3.0 THERMAL EVALUATION

This Section identifies, describes, discusses, and analyzes the principal thermal engineering design of the WMG 150B package. Compliance with the performance requirements of 10 CFR 71 (Reference 3-1) is demonstrated. The details of the thermal evaluation are presented in Reference 3-2 and summarized in this section.

2-7 Specify the use of tamper resistance seals on the licensing drawings and provide details as to how they function.

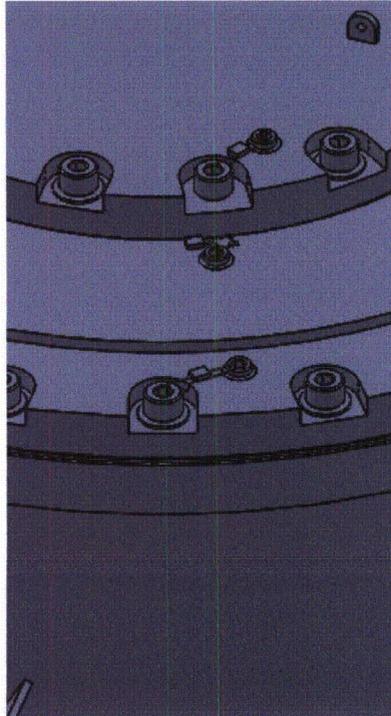
Tamper resistance devices are mentioned in the application, but no details are provided on their use and operation.

The tamper resistant seals, employed in the WMG 150B package, are shown on Sheet 3 (Items 238 and 239). They are specified as commercial grade cable seals, similar to Dickey Manufacturing Company's Defender 1.5 Cable seals with the minimum breaking strength of 500 lbs. These seals are connected between one each of the primary and secondary lid bolts and the pressurization ports as shown in the following sketch.
